**FINAL DRAINAGE REPORT
FOR
LATIGO TRAILS FILING NO. 9
AND
ADDENDUM TO MASTER DEVELOPMENT/
PRELIMINARY DRAINAGE PLAN
FOR LATIGO TRAILS,
EL PASO COUNTY, COLORADO**

September 2021

Add "PCD File No. SF-21-037"

LATIGO TRAILS FILING 9
PROPOSED DRAINAGE MAP
JOB NO. 25175.01
09/13/21
SHEET 1 OF 1

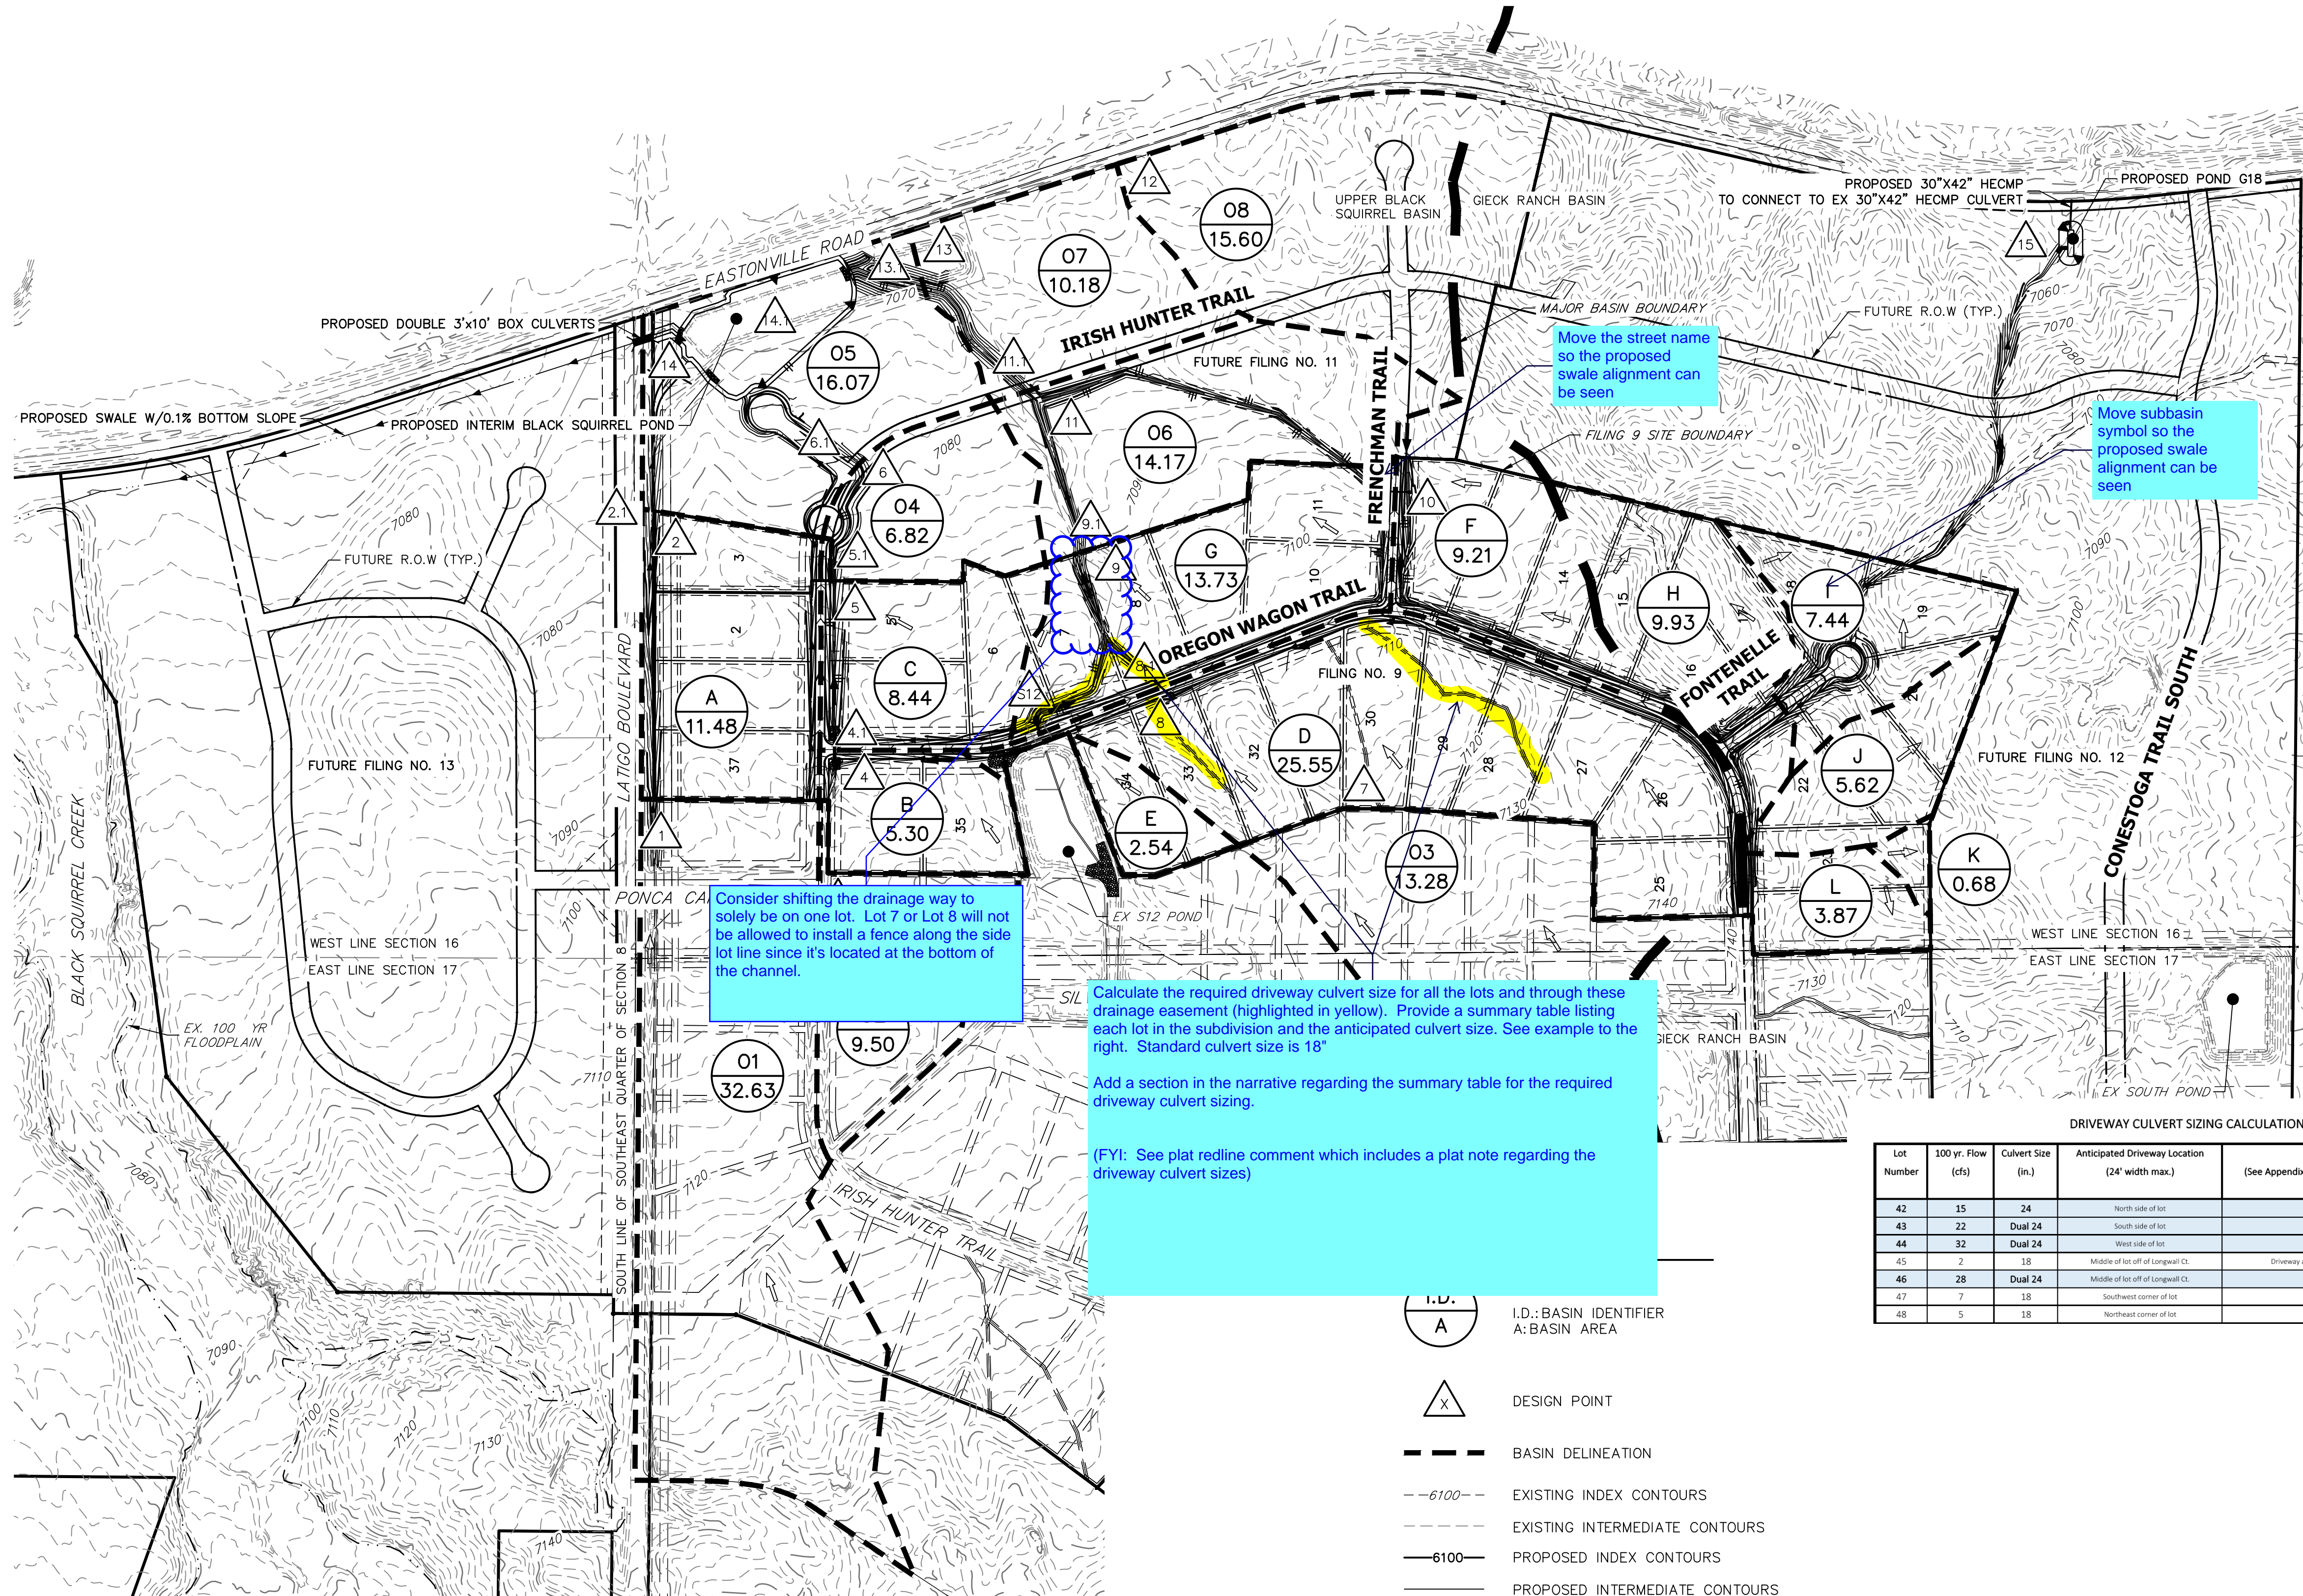
- show a few more drainage flow arrows
- on this map or a new one, include color shading that shows areas tributary to each type of PBMP (each pond, runoff reduction, etc.) and those areas that are not captured by a PBMP, with the applicable exclusion(s) labeled --- for this filing.
